## REMARKS

### I. Drawings

MARK-UP COPY

FIG. 10

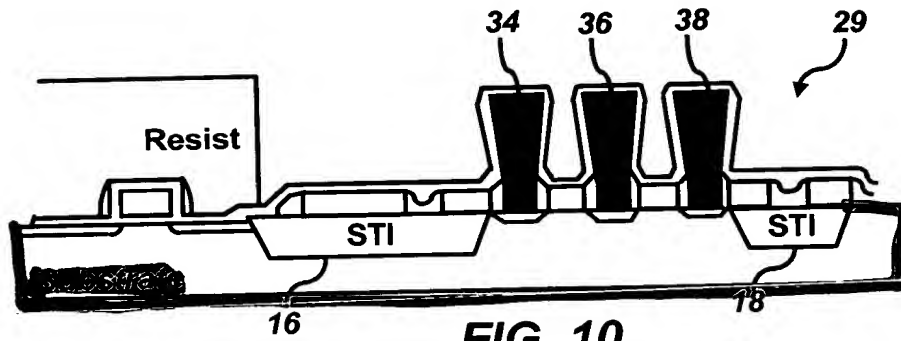
Regarding Fig. 10, the Examiner stated that space TEOS is not shown. Applicant points out that it is not necessary to show a space TEOS, because the

specification clearly points out that Fig. 10 shows the results of a TEOS wet dip. Also, TEOS is discussed thoroughly with respect to Fig. 17. The figures in their totality, including the specification and background provide sufficient enablement thereof. Applicant therefore asserts that this issue has now been removed.

FIG. 11

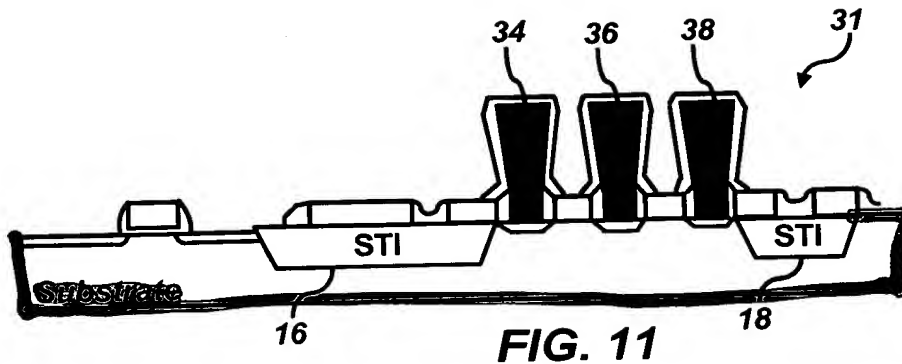
Regarding Figs. 10-15, the Examiner stated that it is not clear what is the material on 34, 36, and 38. The Applicant asserts that it is clear that a resist material is located on 34, 36, and 38 at various stages in the processes of Figs. 10-15. Therefore, Applicant therefore asserts that this issue has now been removed.

FIG. 12

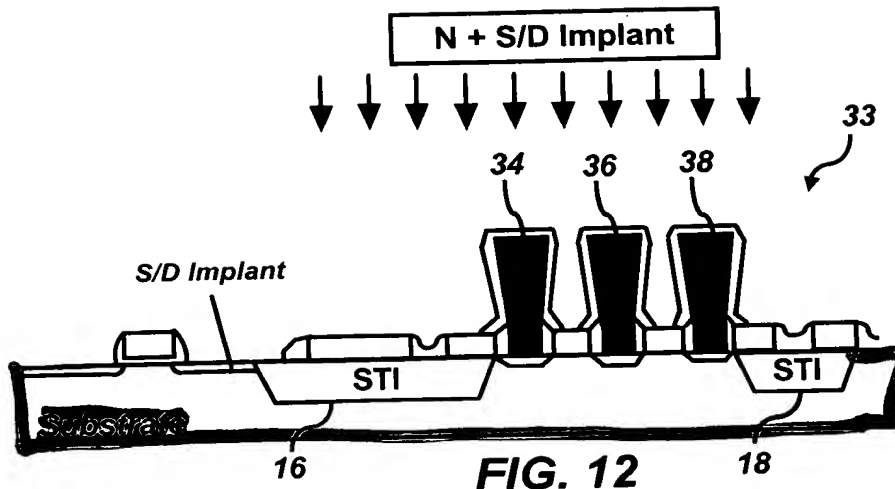
Regarding Fig. 12, the Examiner stated that it is not clear whether S/D implant is done only in the DRAM area. Applicant respectfully disagrees with this assessment. The box labeled "N+S/D Implant" is located sufficiently above the substrate and components thereof to indicate that the implant operation occurs across the entire top thereof. Applicant therefore asserts that this issue has now been removed.
